Rezoning Transportation Analysis

Petition Number: 2018-128

Date	Description
11-19-2018	First Review
12-20-2018	Second Review
05-20-2019	Third Review

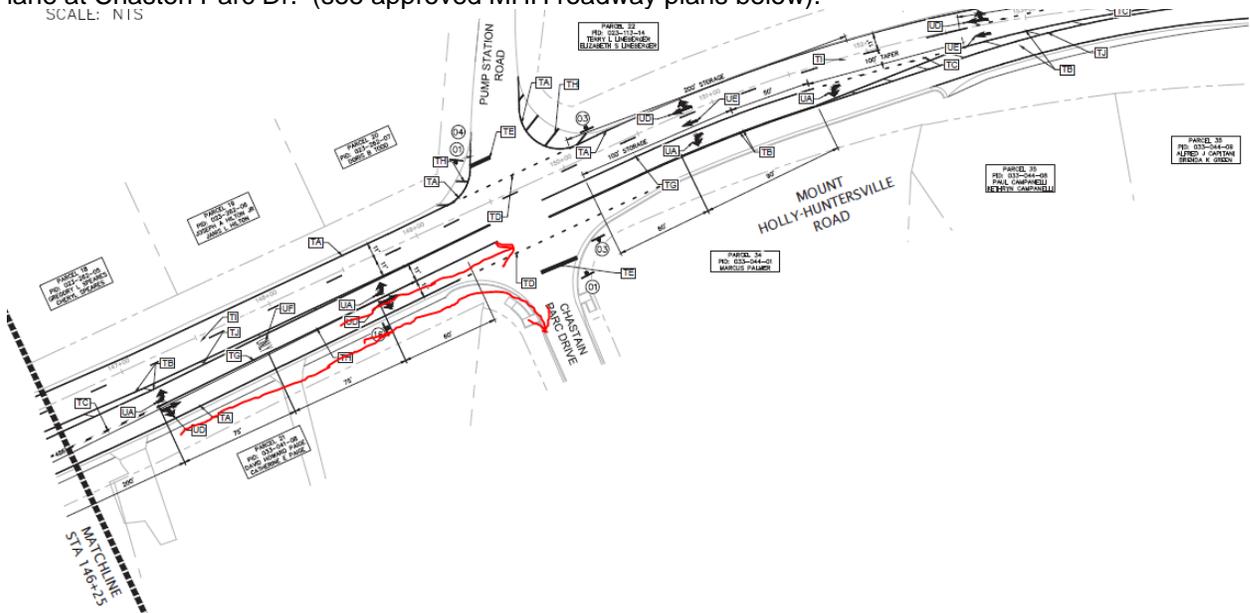
Curbline: The proposed zoning district has a setback measured from back of the existing or proposed future curbline. The location of the future back of curb needs to match the recent approved Mt Holly-Huntersville Rd. Widening Plans to a 4-lane divided facility (see below approved Riverbend Roadway construction plans) to establish the future back of curb location. **Additional information:** The site plan should commit to the dedication of right-of-way for the ultimate cross-section for Mount-Holly-Huntersville Road.

- 4. Revised Comment:** The petitioner needs to revise the site plan and conditional note(s) to depict, label and commit to an additional 11' eastbound MHH travel lane which will terminate as a right-turn drop lane at Chasten Parc Dr. (see approved MHH roadway plans below).
